Access Compliance Report Public Rights-of-Way (Curb Ramps)

Main Street: WEATHERBY_RD Cross Street: ROSSMOOR_WAY Location: N

ADA ID: RPRK211217124055 Ramp Type: Type 1 - Perpendicular Diagonal Initial Pass/Fail: Pass Overall Compliance: No Severity Score: 4

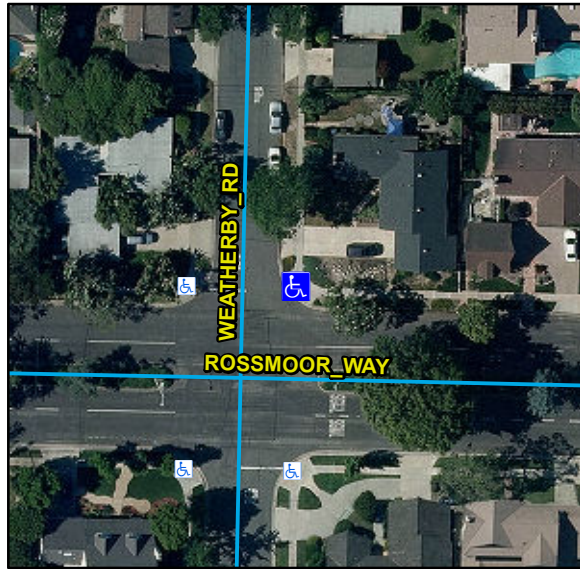
R304.2.1, R304.5.3, R305.2, STD 1115

Crossing 1 Slope (%)	4.5		Crossing 2 Slope (%)	4.1
	Crossing 1 Cross Slope (%)	0.3		Crossing 2 Cross Slope (%)	1.3
Yes	Gutter Ponding	No	Yes	Curb Slope	4.8
Yes	Gutter Lip Height (in)	0		Road Run Slope (%)	0.4
Yes	Gutter Run Slope (%)	3.8		Road Cross Slope (%)	6.4
No	Gutter Cross Slope (%)	3.2			
Yes	Overall Surface Condition: Acceptable		Yes	Perp Joint Present	Yes
	Cross Gutter Present?	No		Spandrel Present?	No
	Replace Cross Gutter?	N/A		Replace Spandrel?	N/A

Remove & Replace Curb Ramp With Two New Directional Ramps or Equivalent. Remove & Replace Gutter.
